**Support Bulletin-SB-24-10008**

**Title: ISB (Implement Stop Button) preventing Master On with Sentinel**

**Product Line: FAS**

**Model: Sentinel**

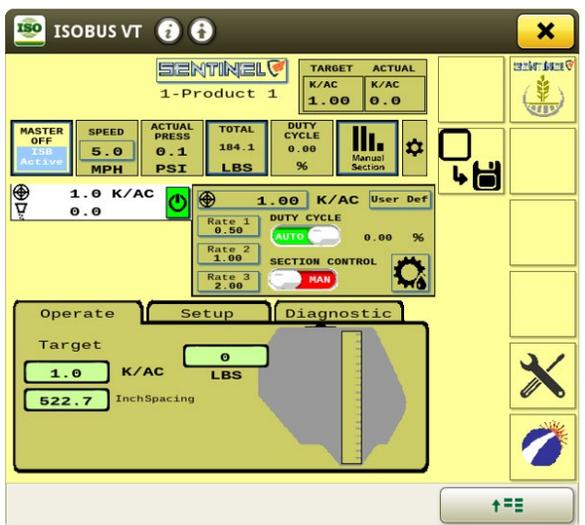
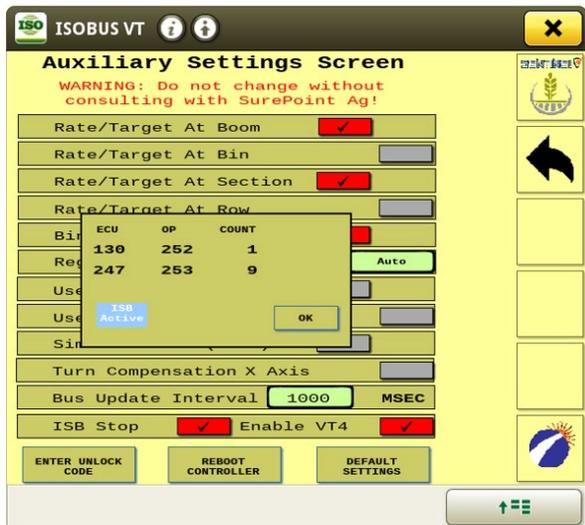
**Overview:** 2024 8RX tractor ECU sending and ISB stop code that will not allow Sentinel to Master On with version 1.5.0 software. If external master is used, the master indicator will be blue and always say "Toggle Master" (image below). If no external switch is used it will never switch to master on (or blip on real fast and immediately back off).

**Solution: Download Sentinel version 1.5.1 software.** In the Auxiliary settings screen, there will be a box labeled ISB Stop. You can either checkmark this box to look for the ISB code or uncheck the box. If you have the "Toggle Master" issue or Master that won't turn on with the soft key you will need to uncheck the ISB Stop box. Default should be unchecked.

Screenshots of setup shown on Page 2

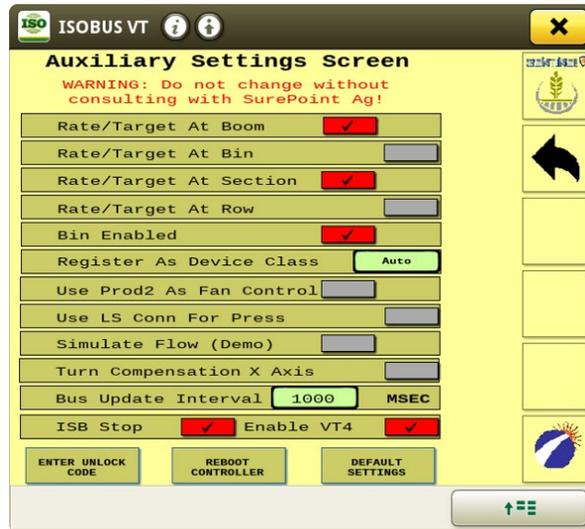
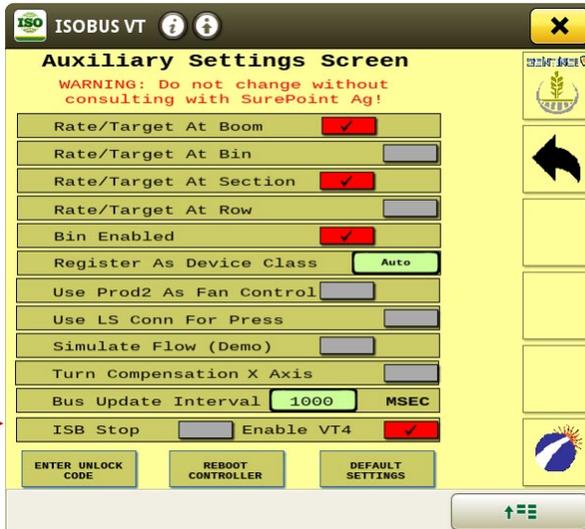
If you have it active and checked and we have an issue you can push that ISB Stop and it will show you an additional box that shows us what ECU's are sending this code. This will be valuable information for engineering if we see more problems with this. Also, if you have it active it will say ISB Active on our Master button on Sentinel. This will tell you how you have it set in the Auxiliary Settings screen.

By pushing the letters ISB Stop you will get the popup box that shows what ECU is sending the ISB stop code
